CITY OF BOULDER
PLANNING BOARD AGENDA ITEM
MEETING DATE: December 3, 2015

AGENDA TITLE: Public hearing and consideration of a Minor Amendment to an Approved Site Plan (LUR2015-00092) to amend the approved Dakota Ridge North design standards to allow fences up to 60 inches (5 feet) in height that back onto an alley to be built to within 18 inches of the alley with a maximum of 42 inches of solid fence and a minimum of 18 inches of lattice above. The Dakota Ridge North PUD lies within the RL-2 (Residential – Low 2) and RM-1 (Residential – Medium 1) zoning districts.

MINOR AMENDMENT to an Approved Site Plan (LUR2015-00092) to amend the approved Dakota Ridge North design standards to allow fences up to 60 inches (5 feet) in height that back onto an alley to be built to within 18 inches of the alley with a maximum of 42 inches of solid fence and a minimum of 18 inches of lattice above. The Dakota Ridge North PUD lies within the RL-2 (Residential – Low 2) and RM-1 (Residential – Medium 1) zoning districts.

Fences and Walls

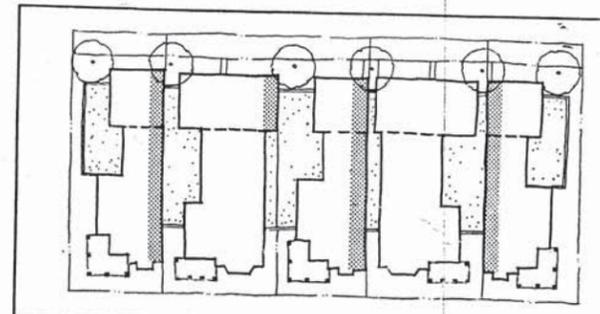
Amended 12/2015 (LUR2015-00092): Fences up to 5 feet in height that back onto an alley may be built to within 18 inches of the alley if the fence is comprised of no more than 42 inches of solid fence and a minimum of 18 inches of lattice above (See Diagram below). Solid fences over 42 inches in height must be setback a minimum of 15 feet from an alley.

5 foot maximum height; maximum 42 inches of solid fence and a minimum of 18 inches of lattice above.
